ASI No. 4 – Lighting Replacement

REFERENCE : 19121 East Wing HVAC Replacement at DelDOT Admin Bldg

OMB / DIVISION OF FACILITIES MANAGEMENT
 OMB / DFM PROJECT NO. M15511000003
 ADMINISTRATION BUILDING
 HVAC REPLACEMENT
 HIGHWAY ADMINISTRATION BUILDING
 800 S BAY RD., DOVER, DELAWARE 19901

1 **ELECTRICAL SECOND FLOOR DEMOLITION PLAN - AREA A**
 ED112A SCALE: 1/8" = 1'-0"

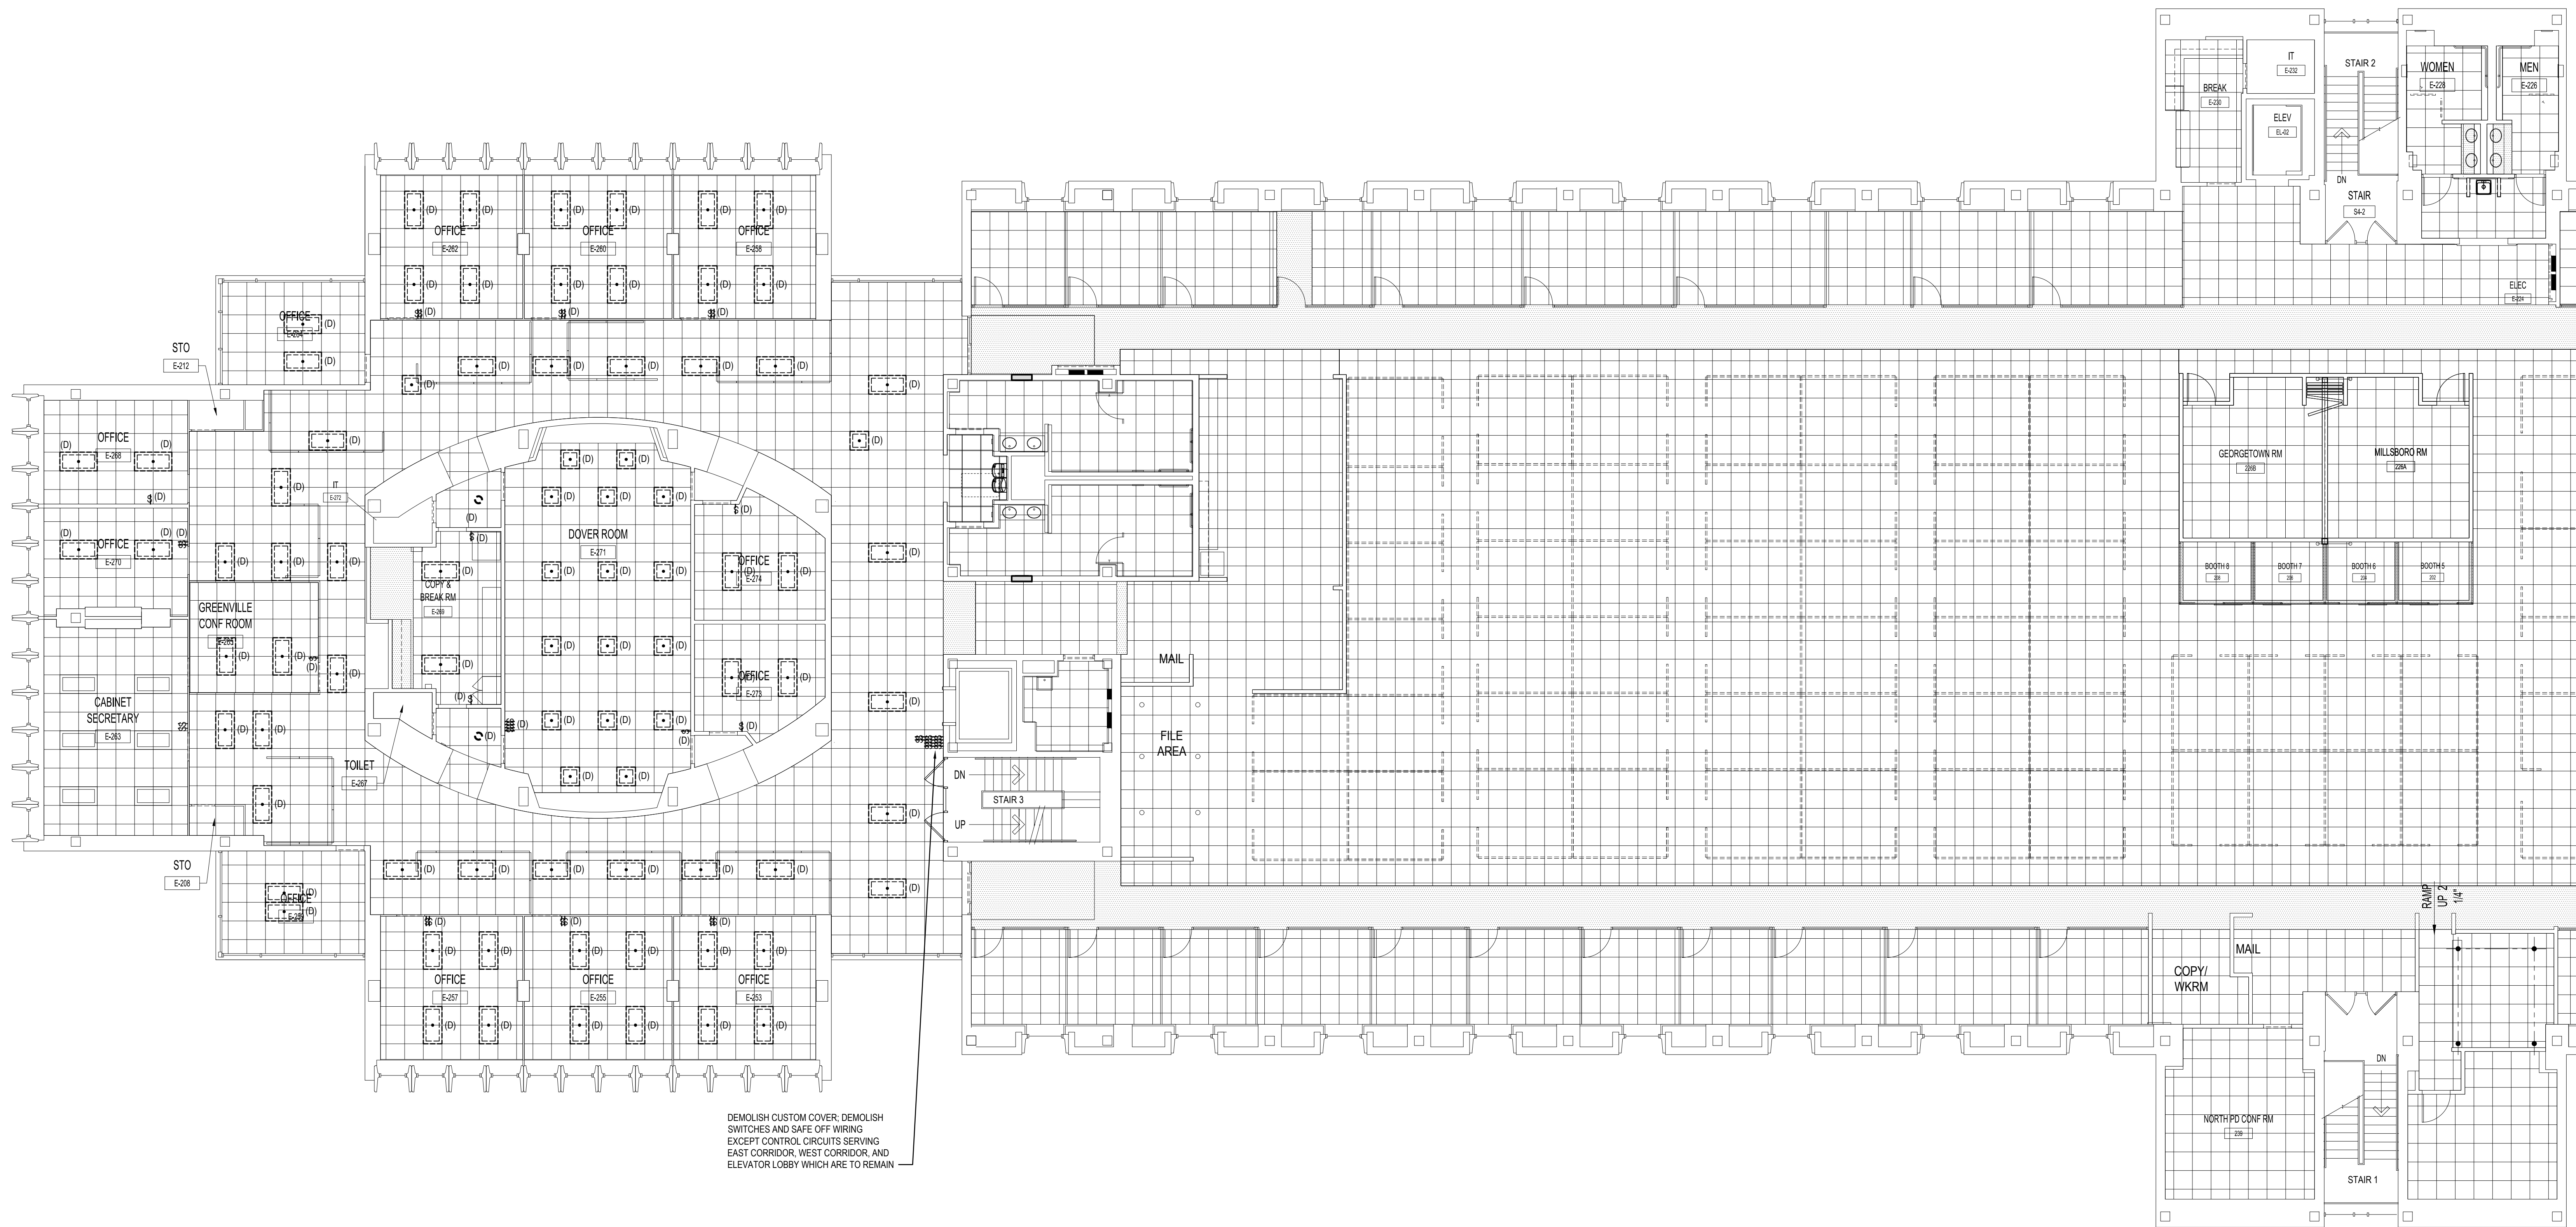
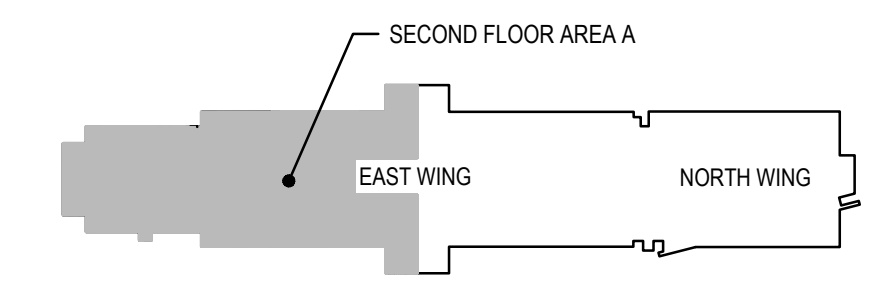
1. Drawing E-000
 - a. Added new lighting controls symbols under Electrical Symbol Legend.
 - b. Added Light Fixture Schedule.
2. Drawing ED112A – Added new drawing with lighting and lighting devices demolition work.
3. Drawing E112A – Added new drawing with new lighting and lighting device replacements.

ELECTRICAL DEMOLITION NOTES:
 1. ALL DEMO FIXTURES AND SWITCHES ARE INDICATED IN THICK LINES WITH THE (D) NOTATION. ALL WIRING IS TO BE RETAINED AND REUSED IN NEW CONSTRUCTION.

1
 ELECTRICAL SECOND FLOOR NEW WORK PLAN - AREA A
 SCALE: 1/8" = 1'-0"

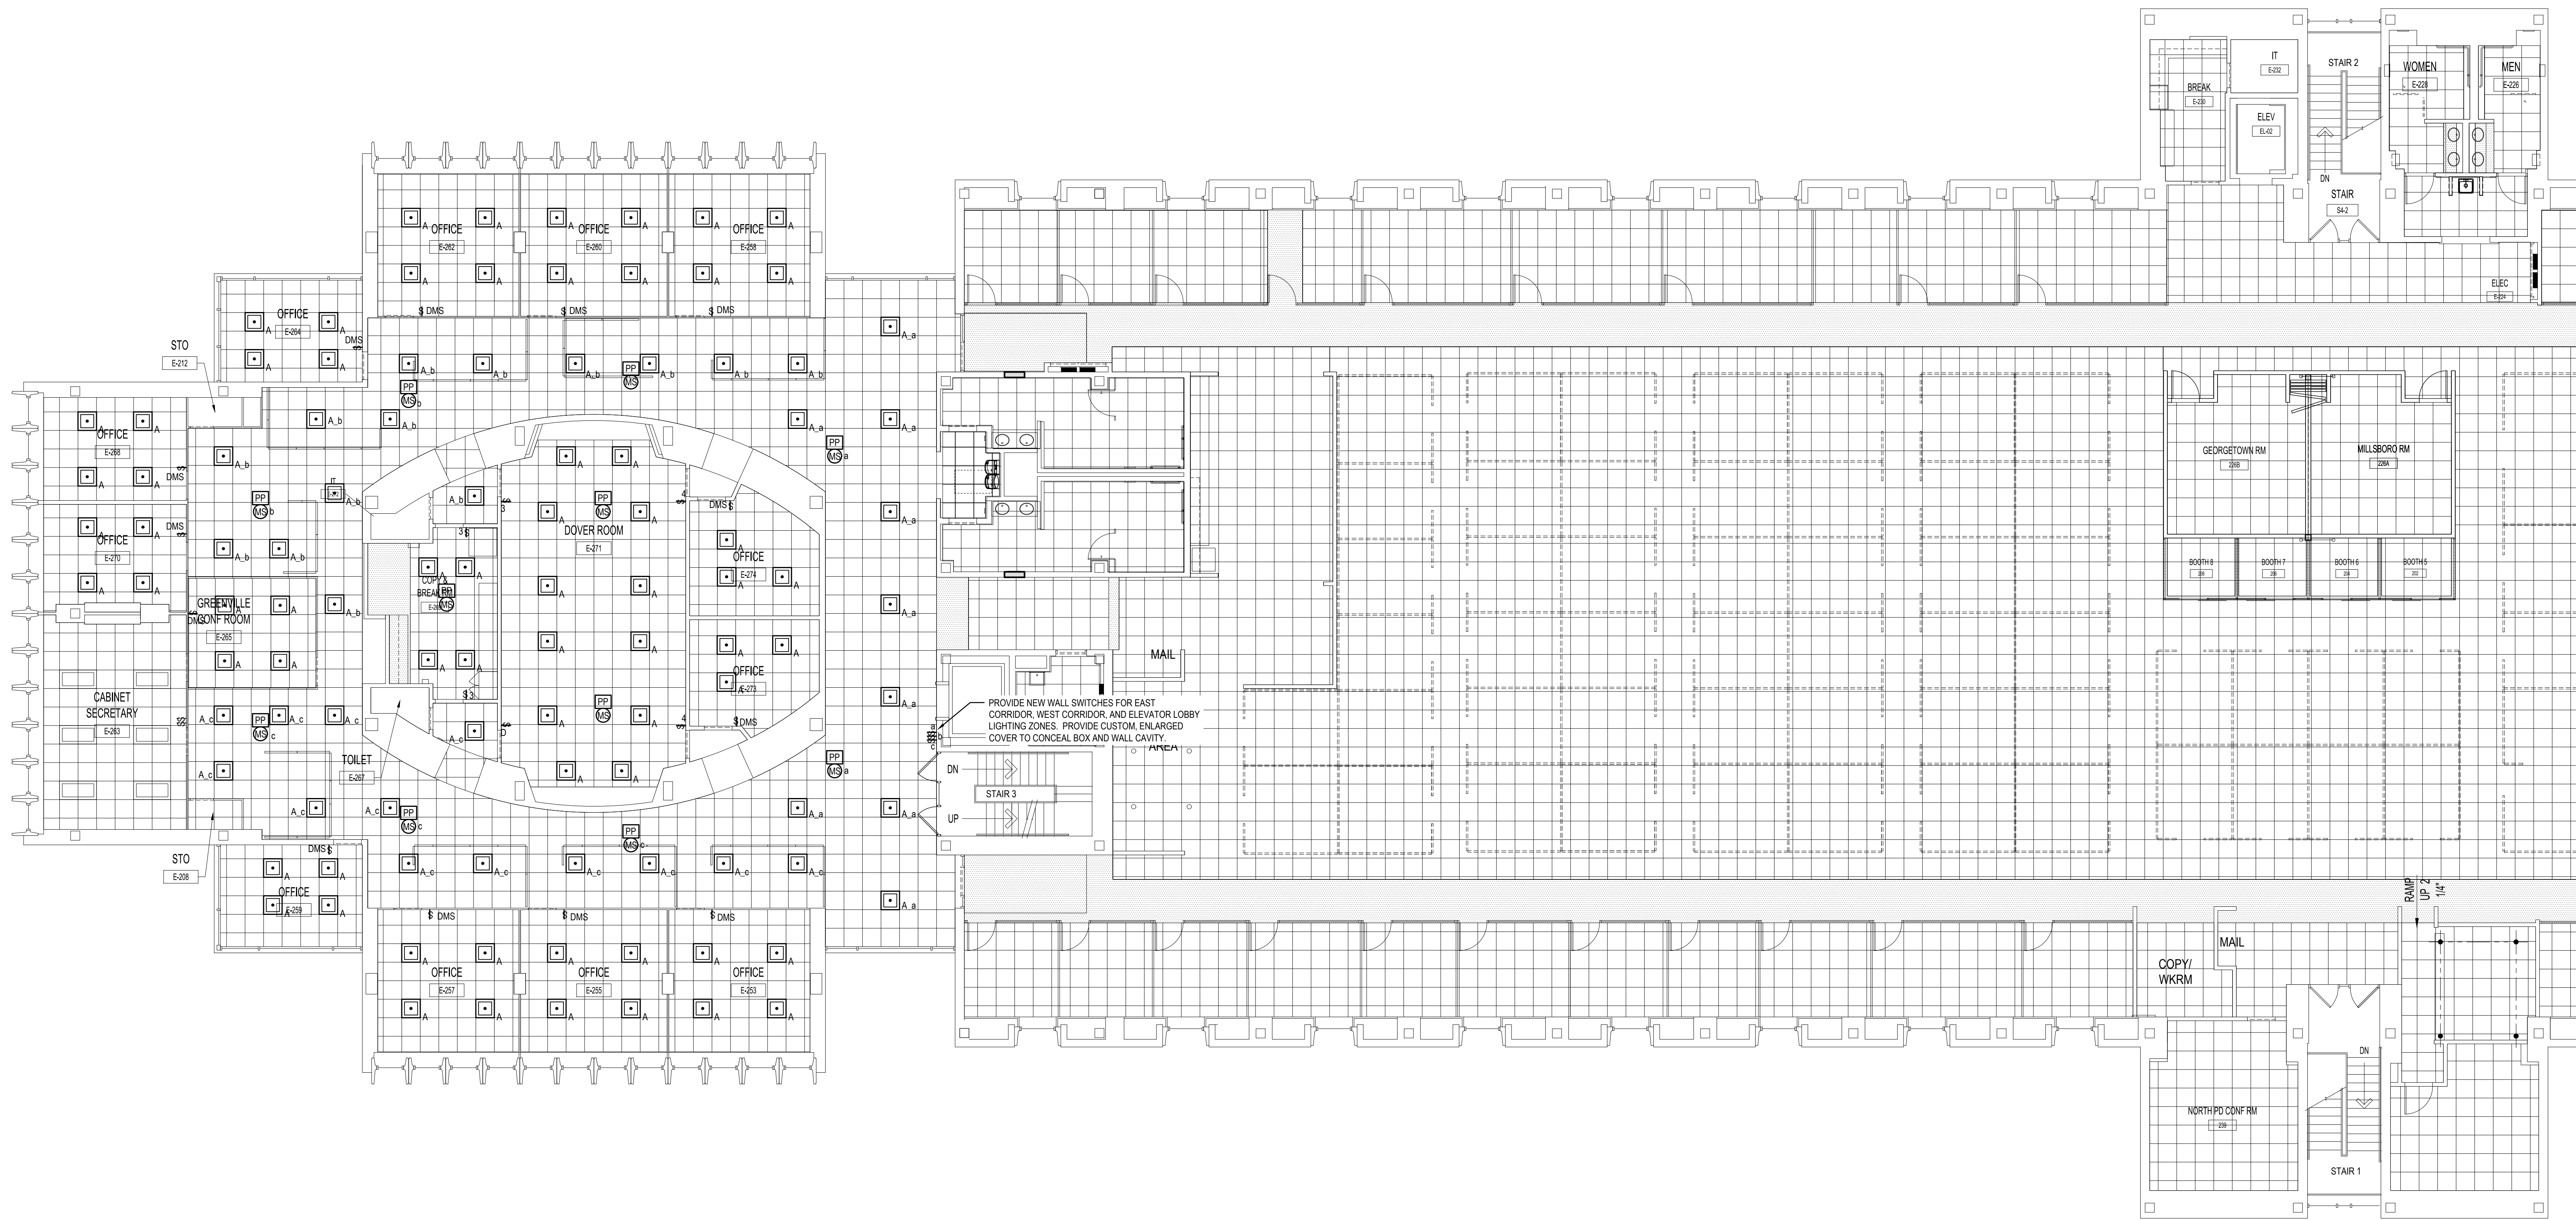
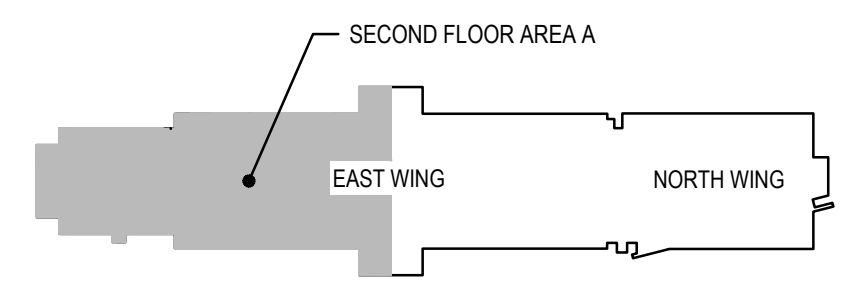
- ELECTRICAL NEW CONSTRUCTION NOTES:**
1. PROVIDE NEW LIGHT FIXTURES, SWITCHES, MOTION SENSORS, AND POWER PACKS AS INDICATED ON DRAWING.
 2. ALL LIGHTING DEVICES ARE TO BE ASSOCIATED AND WIRED WITH THEIR RESPECTIVE LIGHT FIXTURES WITHIN THE OFFICE/SPACE UNLESS INDICATED OTHERWISE.
 3. ALL WIRING IS TO BE REUSED TO RECONNECT TO NEW LIGHT FIXTURES AND SWITCHES. PROVIDE WIRING EXTENSIONS AS NECESSARY.
 4. FOR ALL NEW MOTION SENSORS AND POWER PACKS, PROVIDE NEW 2#12 - #120 - 3/4" WIRING AND LOW VOLTAGE WIRING AS NECESSARY. SEE E-000 FOR MORE DETAILS.
